Project No. 2020-7047000
Revision No. {2.}

UNSW Health Translation Hub Project (SSD-10822510)

Flood Modelling Assessment

SCH-CIV-RPT-00001

Site Plan

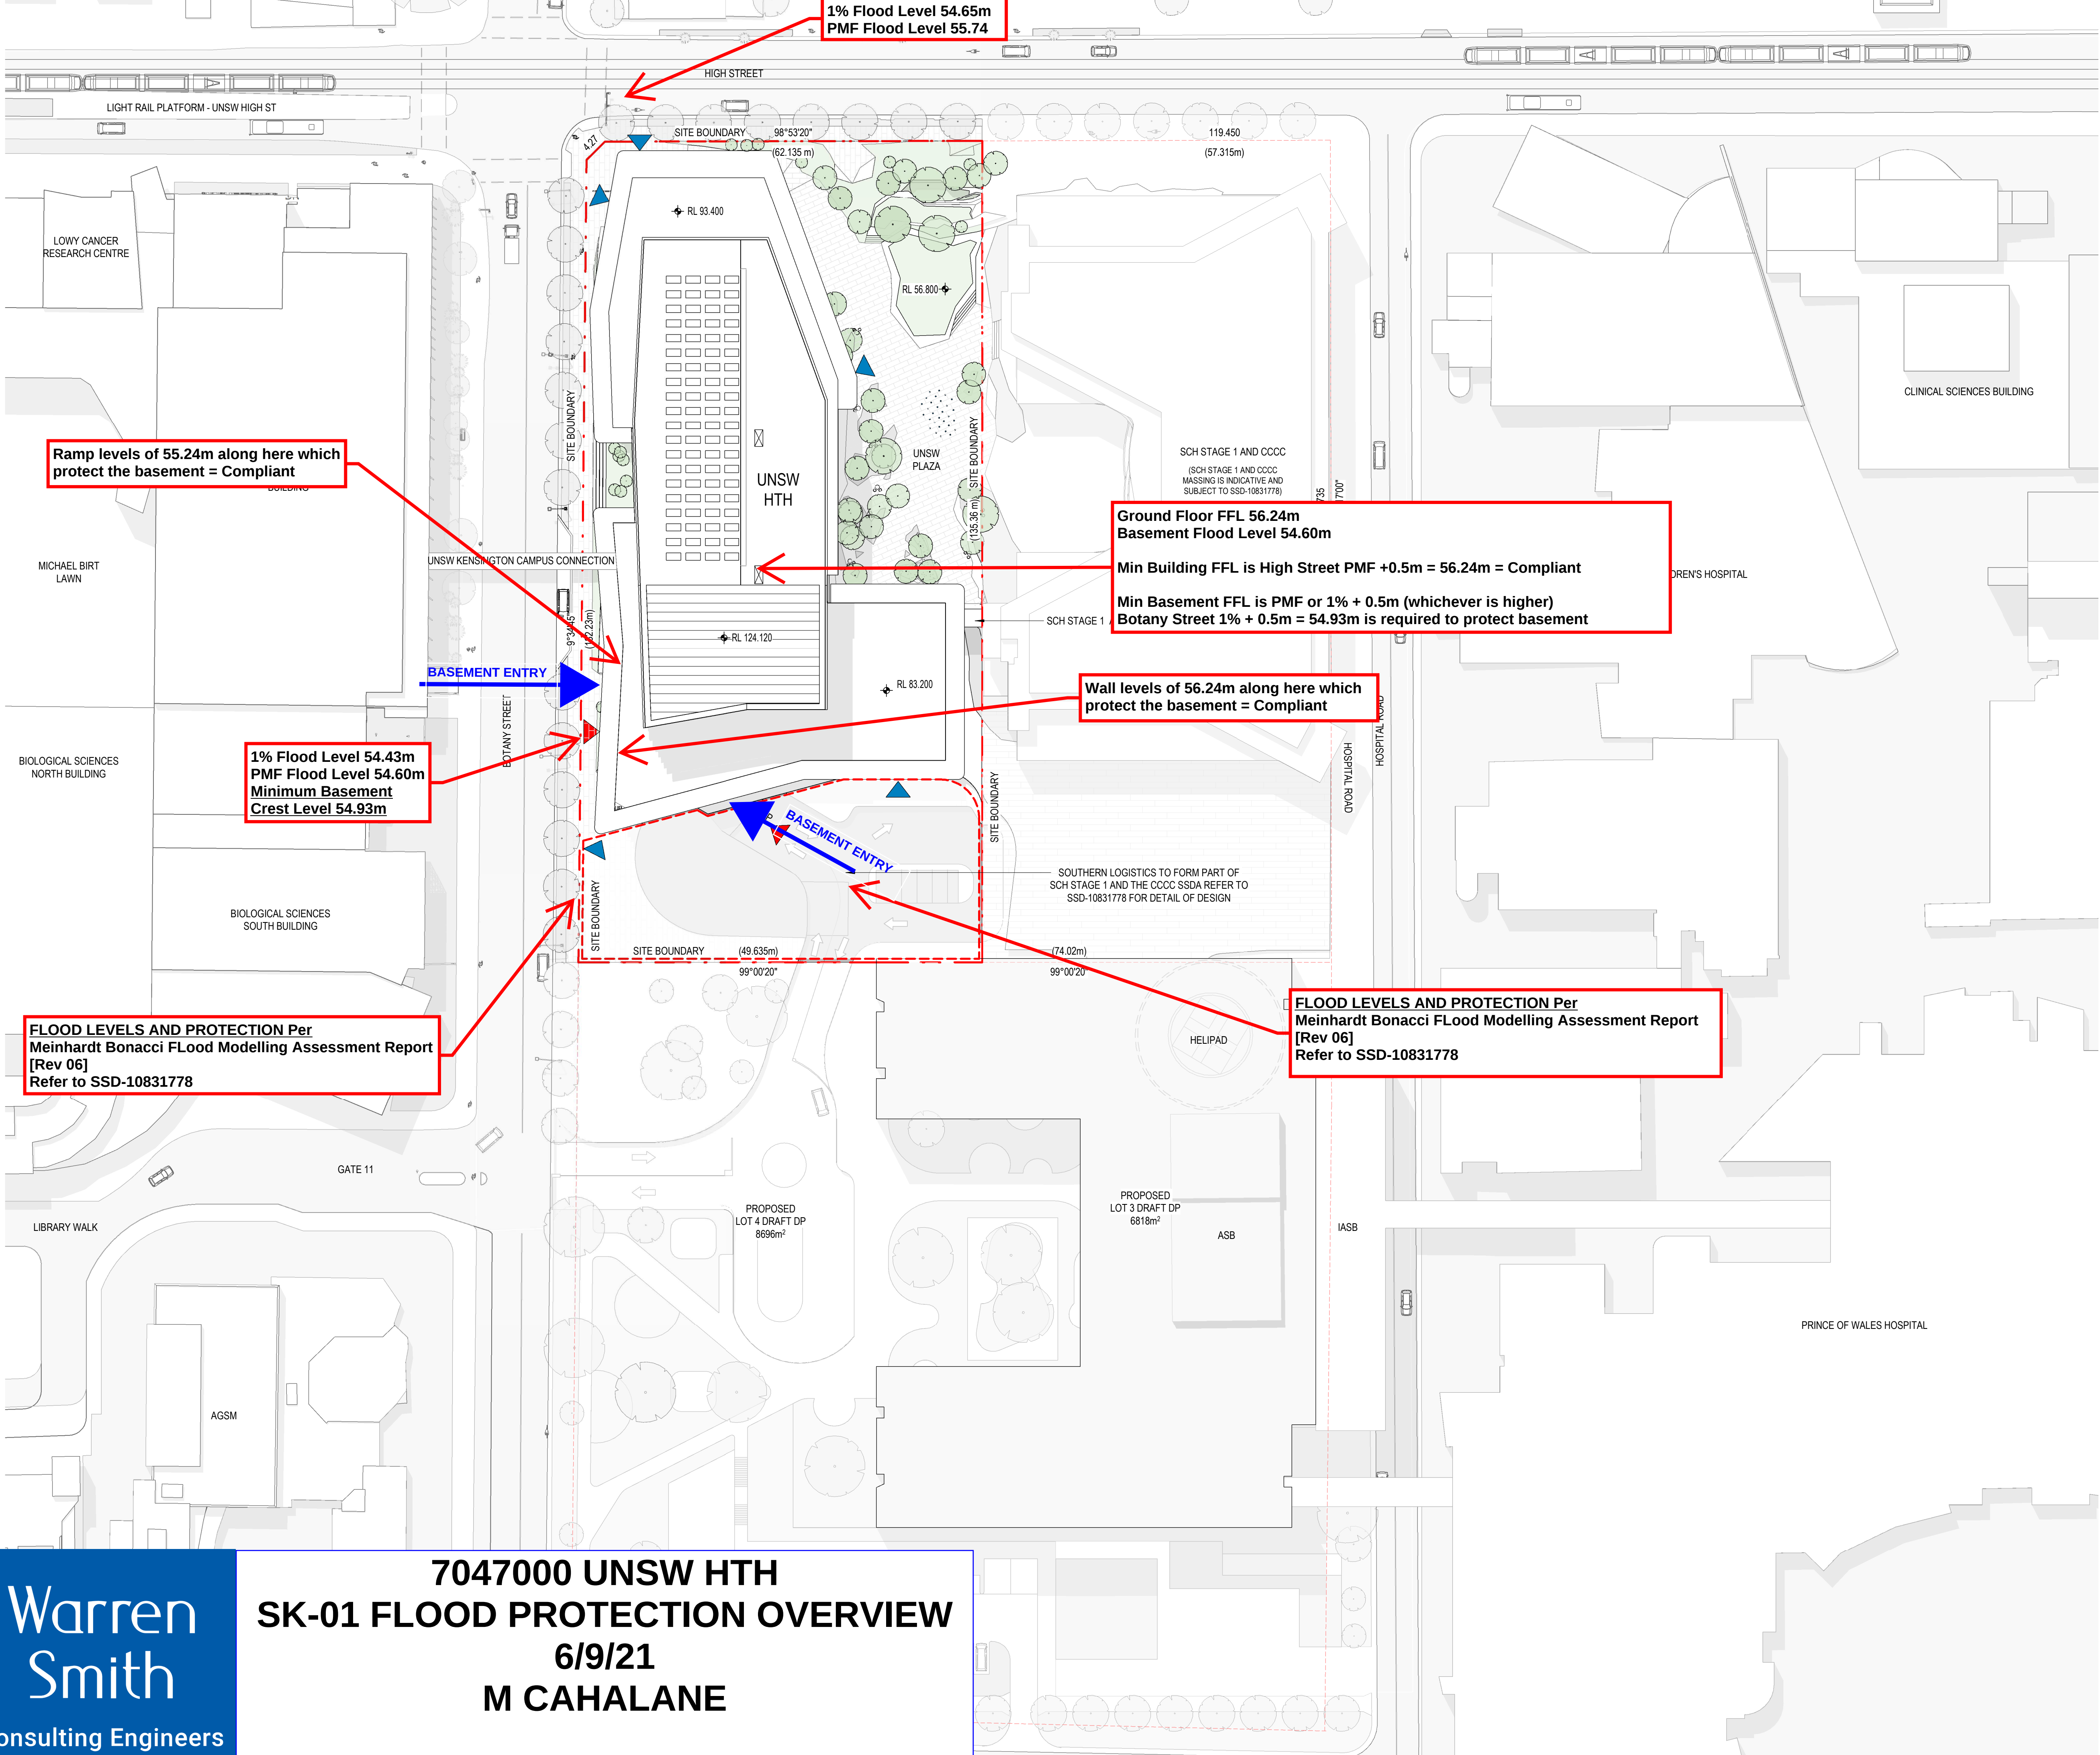
A basement is proposed for the loading dock, bicycle storage and plant. The proponent must describe how the basement is protected from flooding at the PMF level or 1% annual exceedance probability event level plus 500mm freeboard.

We can confirm that the basement is protected from flooding to the PMF and 1% plus 500mm levels as follows

- Protection of entry at Botany Street frontage with a ramp crest of **RL 55.24m** with a 1% plus 500mm level of **54.93m** and a PMF level of 54.60m.
- Protection of basement entry ramp from the south as presented in the Meinhardt Bonacci 'Flood Modelling Assessment' revision 5 dated 6th August 2021 which confirms that *'The basement entry off Botany Street is protected by a crest entrance level in the forecourt set at the 1% AEP plus freeboard level. Additionally, please note that the adjacent structural walls of the entry ramp to the basement are to be set at a height above the 1% AEP plus freeboard level'*.

Confirmation of the above provisions are enclosed in SK-01 - Flood Protection Overview and the referenced report from Meinhardt Bonacci.

Project Name SYDNEY CHILDREN'S HOSPITALS STAGE 1 - CCCC BUILDING (SCH1/CCCC)	Drawn NMF	Date 25/07/2021	North 
Drawing Title NORTHERN BOUNDARY - PROPOSED FLOOD PROTECTION MEASURES	Project Ref 12221	Drawing No SK 210725-01	Rev B

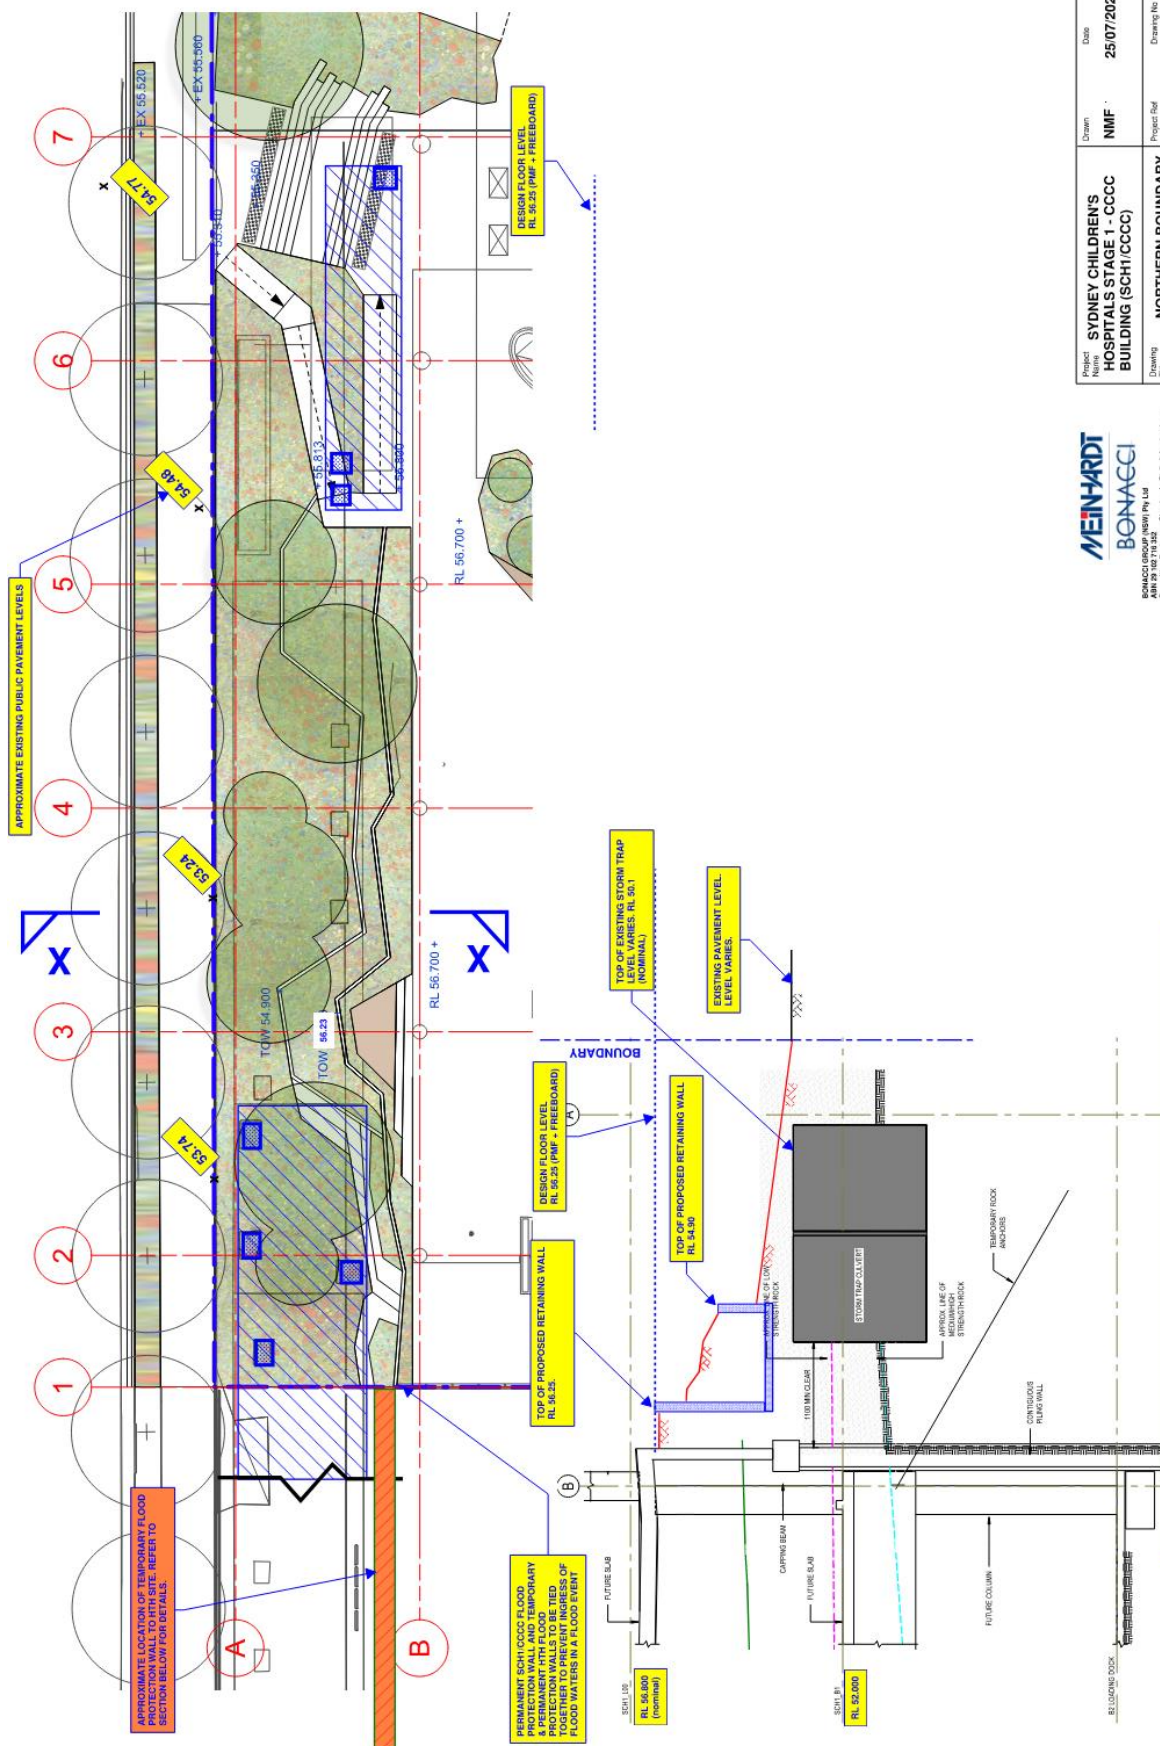
1. A description of the flood barrier, including the following: - Material type	The proposed material type for the permanent flood protection wall is concrete with a reinforced concrete base. The permanent flood protection wall is proposed to be integrated with the landscape design to provide for a suitable urban outcome

- Finished surface levels at suitable intervals along the top of the barrier.	The top of retaining wall will be set at the flood design level (PMF + freeboard). Please refer to the attached drawing (SK 210725-01) provided in Appendix C.

- How the barrier would tie in to surrounding ground to prevent outflanking, i.e. floodwater making its way around the barrier, and	The SCH1/CCCC barrier and main entry steps will extend sufficiently to the east to marry in the proposed Hospital Road levels. The Hospital Road levels will also be at or above the design flood level in order to prevent outflanking of the flood waters from the east. The temporary HTH barrier designed by Meinhardt Bonacci will extend far enough to the west to prevent outflanking to the west. The permanent HTH flood barrier is to be designed by others. Please refer to SSD-10822510. The SCH1/CCCC permanent barrier will suitably tie into the temporary HTH barrier to prevent outflanking of the flood waters from the west of SCH1/CCCC. The tie in detail between the SCH1/CCCC permanent wall and the HTH temporary wall is to be confirmed once the HTH barrier design is developed. The junction will be suitably designed to hold back any flood waters.

- How the barrier would interface with the building, e.g. whether any footings are likely to be required and if these can feasibly be provided separately to the hospital building.	Refer to the attached sketch in Appendix C which shows the proposed flood protection wall structure, independent of the main building.

2. The Flood Modelling Assessment states that the flood barrier must be watertight and able to resist hydrostatic pressures. In addition, the flood barrier below the PMF level must be designed to achieve the following: - withstand the impact of likely debris, such as floating cars.	Please refer to the attached drawing (SK 210725-01) provided in Appendix C illustrating a proposed lower height wall in front of the taller main flood protection wall. The proposed lower wall can act as a protective barrier. This concrete retaining wall will be designed to withstand debris from the flood waters. The rate of flow of flood water (and therefore debris) in this urban (i.e not tidal or riverine) and relatively flat setting is not anticipated to be fast.
